Puente Power Project (P3)
Oxnard, CA

Refinement to Transmission Interconnection

August 2016

Submitted to:
The California Energy Commission

REVISED FIGURE 3-2

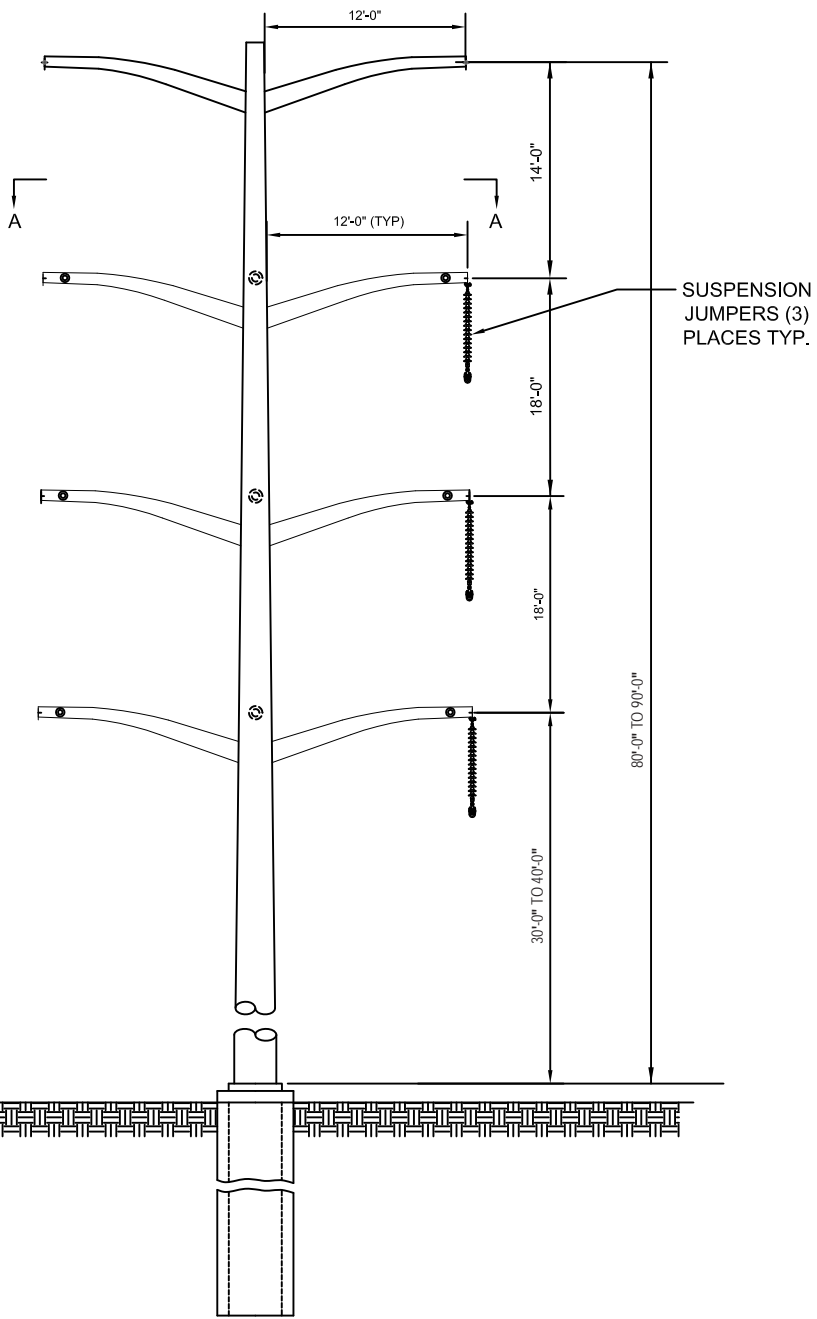
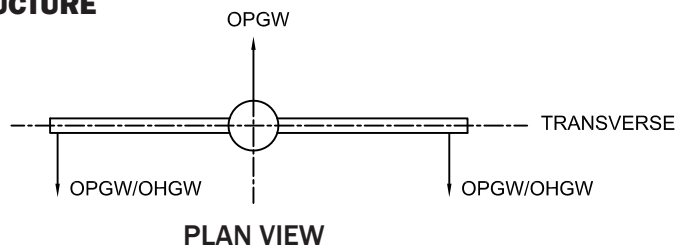
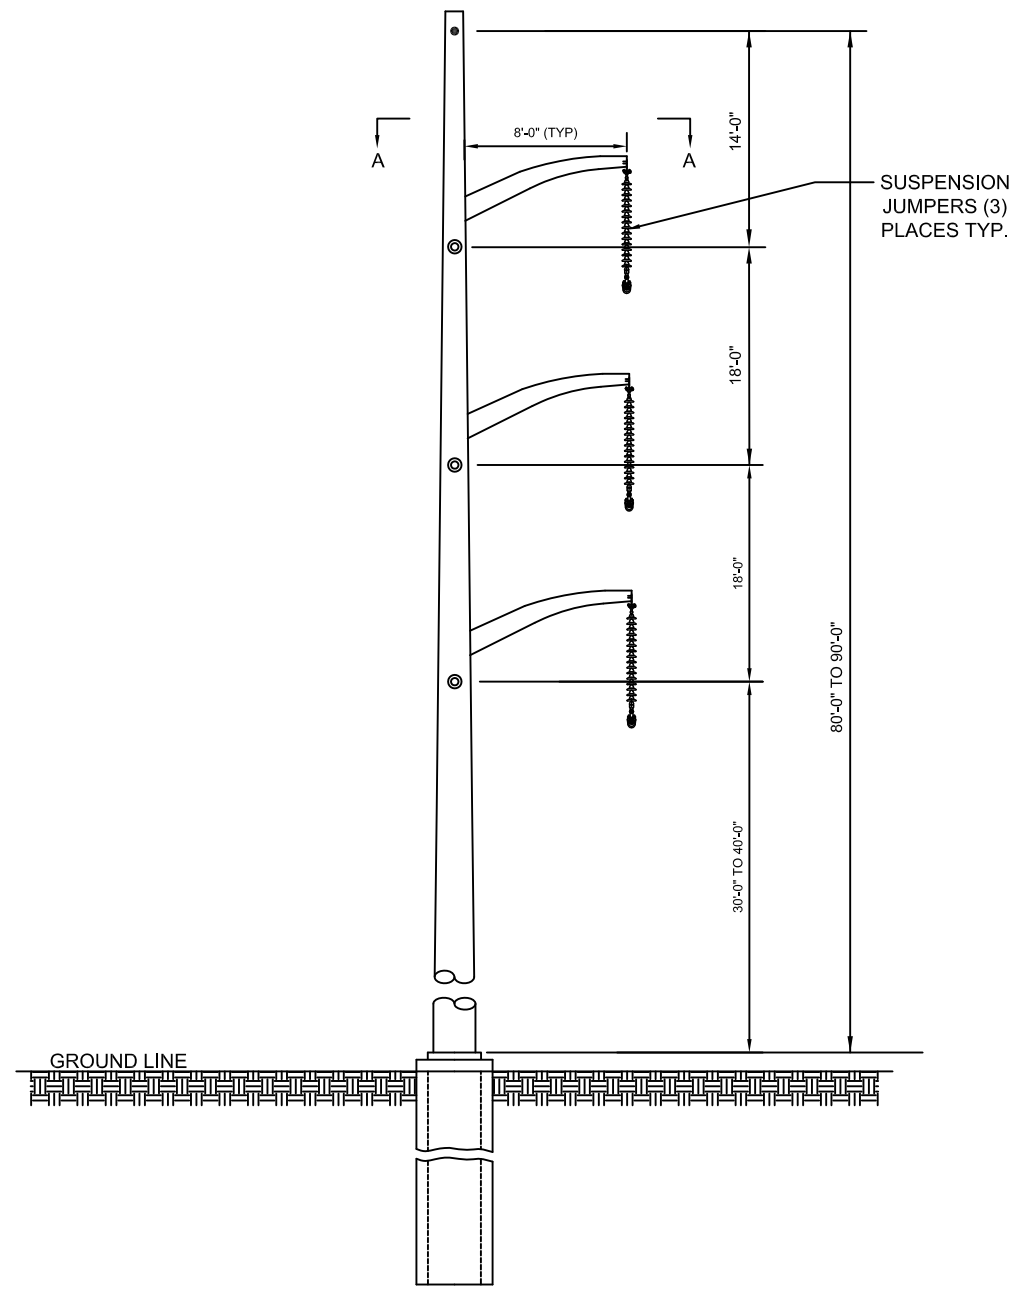
The new 220-kV circuit line from the project switchyard to the new take-off structure will use one steel pole structure. The steel pole and the take-off structure will be constructed of weathered or galvanized steel. The steel pole structure will be bolted or slip-fit design. The pole will be a single-circuit structure, and the take-off structure will be a double-circuit structure. The single-circuit structure will be approximately 80 to 90 feet tall; the double-circuit structure will be approximately 80 to 90 feet tall, with phase conductors that may be arranged horizontally, vertically, or in a delta configuration, depending on the requirements for particular structures. The vertical configuration will be the predominant configuration type (see Revised Figure 3-2).
